Product Enhancement

Machines/Models: All SL-20D Series
Work Platforms

SERVICE BULLETIN: 93.2

PURPOSE: To notify of a change to improve steering while driving at high system pressure.

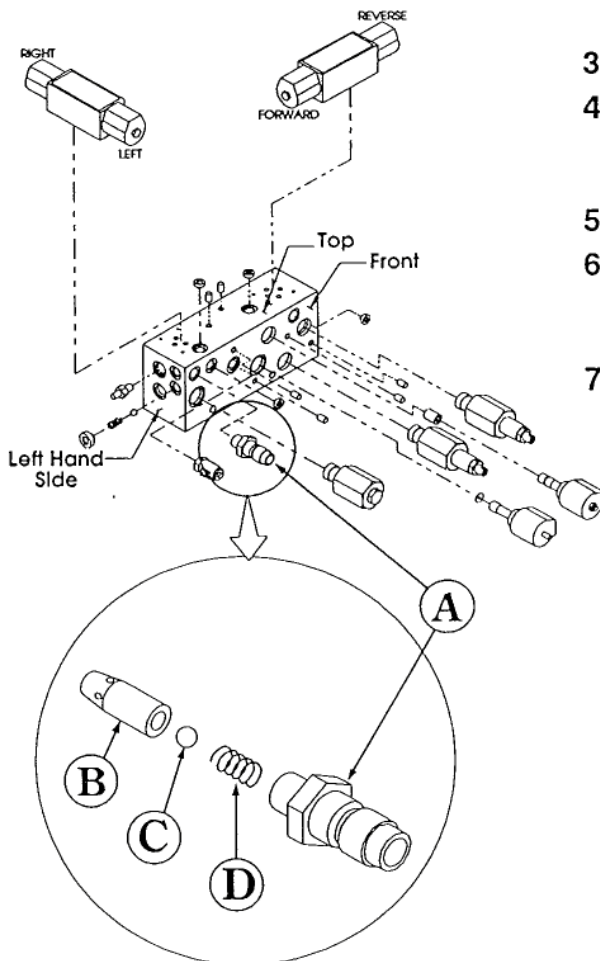
1. Remove the gage quick disconnect fitting.
2. Install spacer, ball and spring.
3. Re-install gage quick disconnect fitting.

1. Remove gage quick disconnect fitting, Item A.
2. Insert spacer, Item B, tapered end first, into quick disconnect port.
3. Tap spacer to bottom of port with drift punch.
4. Insert ball, Item C, into port and seat against spacer by striking the ball lightly with a drift and hammer.
5. Insert spring, Item D, into the port.
6. Install the gage quick disconnect fitting, compressing the spring, and tighten the fitting to 25 Ft/Lbs (26 Nm).
7. Operate the machine and check for proper function and leaks.

1- 30675-000-00 Check ball kit.
